65-2887 Payette River Maps

Weilmunster Payette River Map

65-9042. Place of Use

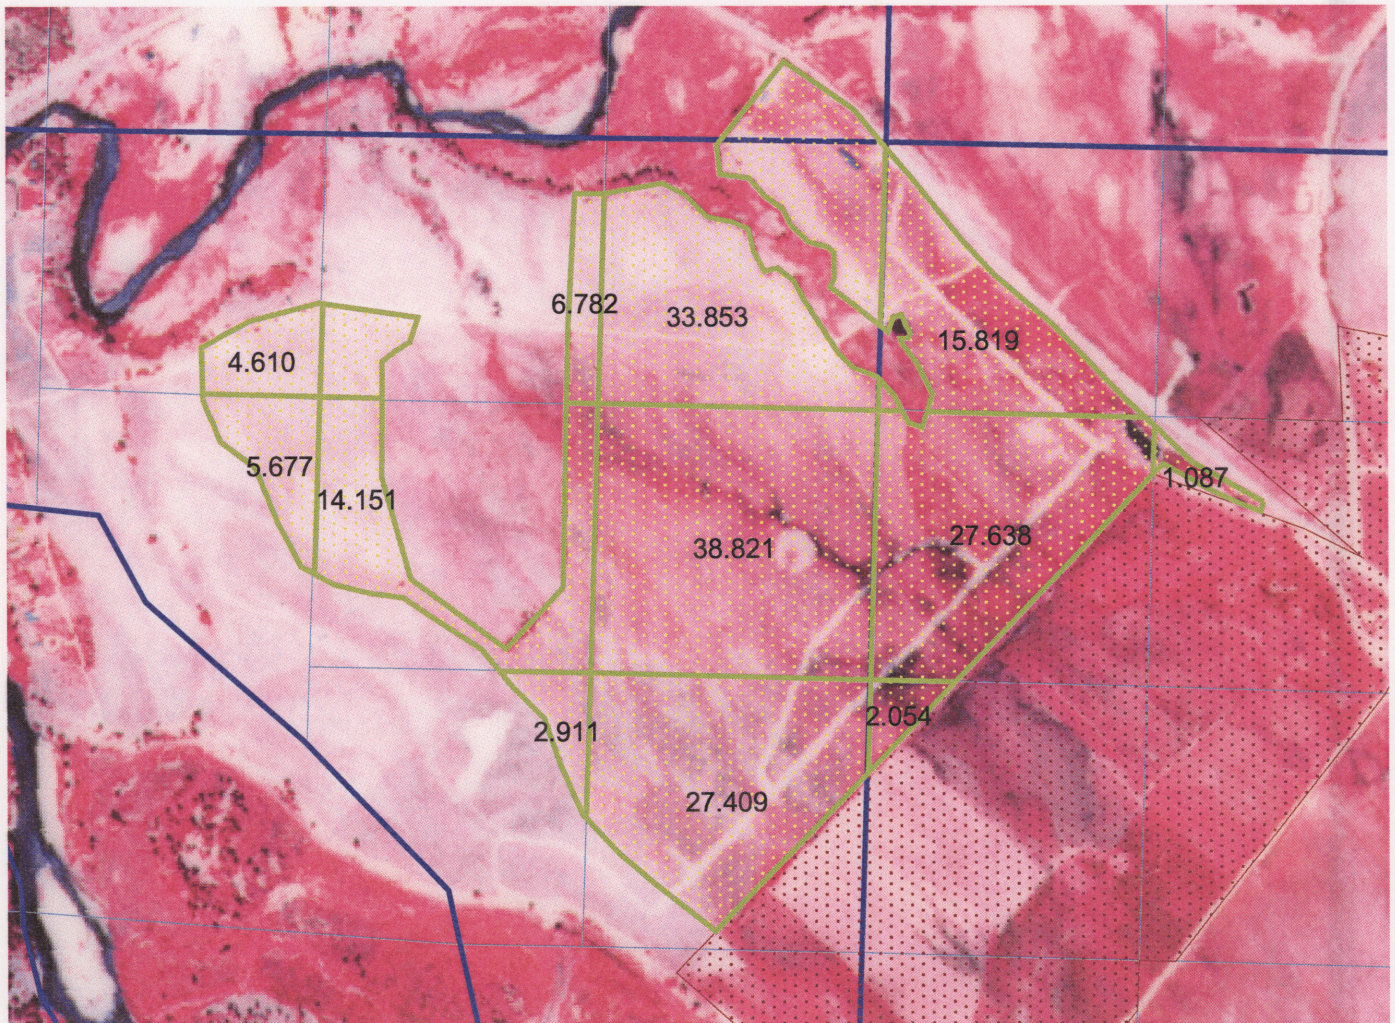
The applicant states that the lands associated with this water right were incorrectly mapped and described by both the Payette River Decree (PRD) and the Snake River Basin Adjudication (SRBA). I reviewed the PRD and SRBA maps, and I would agree with the applicant's assessment. The acres shown on the maps do not match the legal descriptions listed on either decree. The SRBA agent does mention a discrepancy in the acres, but there was no record in the file that she contacted the owner to clarify the water right discription. The maps clearly show that 180 acres were irrigated on the applicant's property. The above map shows the lands shown irrigated by the PRD aerial photo maps.
